Re: Crown-Indigenous Relations and Northern Affairs Canada's (CIRNAC's) Reply to Agnico Eagle's Response on the 2024 Annual Report Review Comments for Meadowbank and Whale Tail Gold Mine Projects, Type A Water Licence Nos. 2AM-MEA1530 and 2AM-WTP1830.

Technical Review Memorandum

Subject: Crown-Indigenous Relations and Northern Affairs Canada's (CIRNAC's)
Reply to Agnico Eagle's Response on the 2024 Annual Report Review
Comments for Meadowbank and Whale Tail Gold Mine Projects, Type A
Water Licence Nos. 2AM-MEA1530 and 2AM-WTP1830.

Figure 6-2: Water quality model results for TDS (top) and As (bottom) in Goose Pit during Operations Phase plotted alongside available monitoring data.

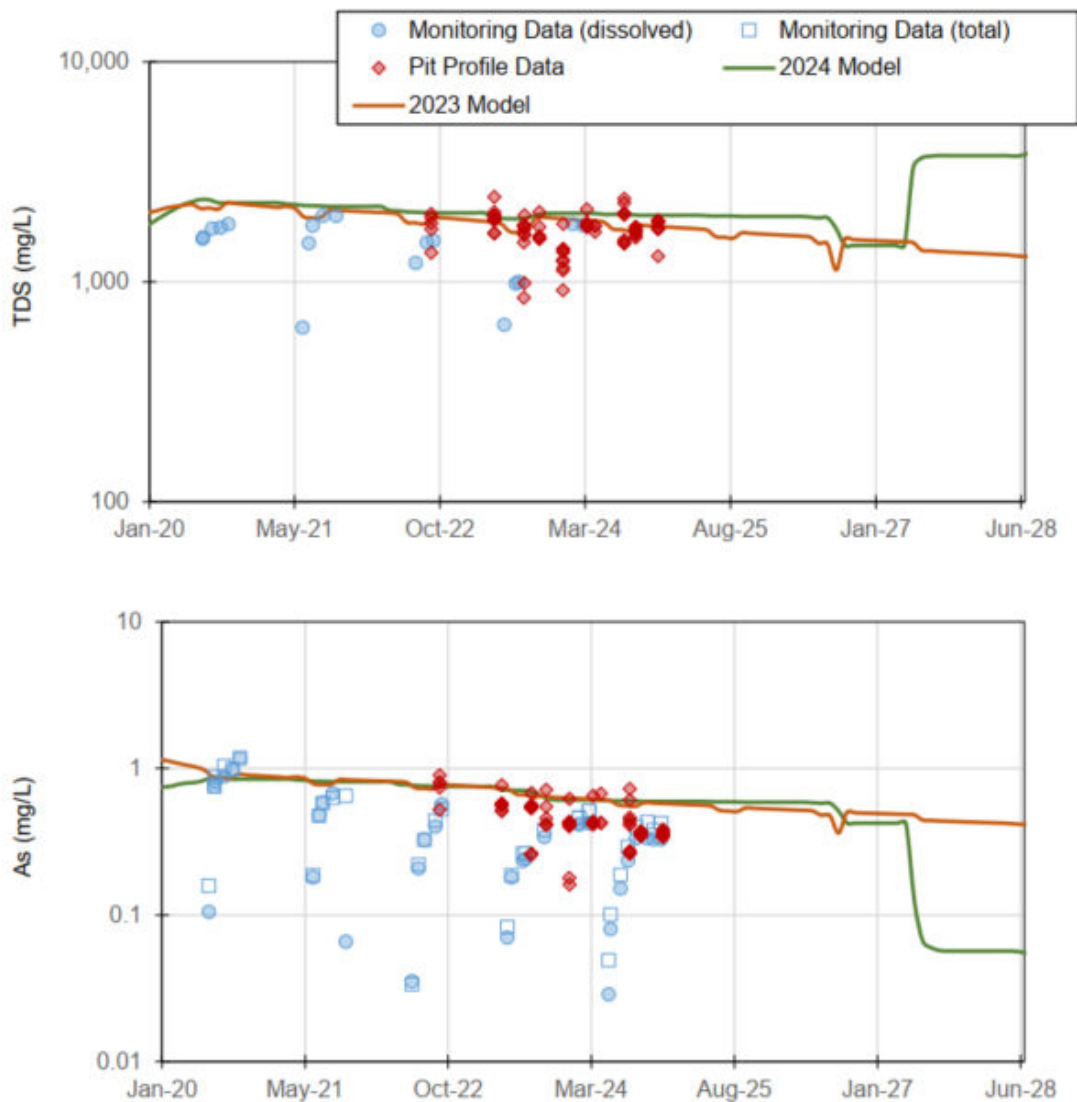
(R-04) CIRNAC recommends that Agnico Eagle perform quantitative sensitivity analyses of their water quality predictions. The analyses should quantify potential variability in all major source terms and associated pathways (e.g., elevated arsenic seepage from pit walls, waste rock storage facilities (WRSFs) and mine areas). CIRNAC acknowledges that some sensitivity analyses have already been performed in prior predictions, but a more comprehensive analysis of all variables is justified. The additional information is necessary to verify Agnico Eagle's conclusion that their modelling results are conservative and over-predict any potential impacts. Results from past predictions demonstrate that this is not the case.

CIRNAC notes that past experience has shown measured concentrations can differ from predictions by one to two orders of magnitude, either due to system complexity, strategic changes, or underlying uncertainty. Given that closure decisions, such as the timing of pit reconnections, carry long-term environmental implications, it remains critical to ensure that decision-making is based on a conservative understanding of potential outcomes. Quantitative sensitivity analyses provide a systematic way to evaluate the range of plausible conditions and to test whether conclusions drawn from modelling are robust across uncertainties.

CIRNAC, therefore maintains its original recommendation that Agnico Eagle undertake quantitative sensitivity analyses of their water quality predictions. This would complement the current iterative calibration approach, ensuring that both model refinement and conservative risk assessment inform closure planning and decision-making.

Agnico Eagle disagrees to the degree of uncertainty in the model. The differences between model outputs are not because of uncertainty, rather they are because of changes in water management strategy and movement of water, in particular, for Goose Pit and IVR Pit. For example, Figure 6-2 shows monitoring data compared with the 2023 and 2024 models. Generally, both water quantity (water levels) and water quality (concentration) are in agreement with monitoring results, and there is a high degree of certainty in model predictions.

Differences between model iterations are also explained by source term updates through laboratory testing and model calibration to site monitoring data. Agnico Eagle progressively investigates opportunities for model improvements via model verification and calibration exercises each year. These exercises provide an opportunity to verify model results with monitoring data and calibrate model components where necessary. It is Agnico Eagle's opinion that there is greater benefit to taking this approach, whereby the model is iteratively

validated and updated based on real world data, then by running a broad range of 'what if' sensitivity analyses.
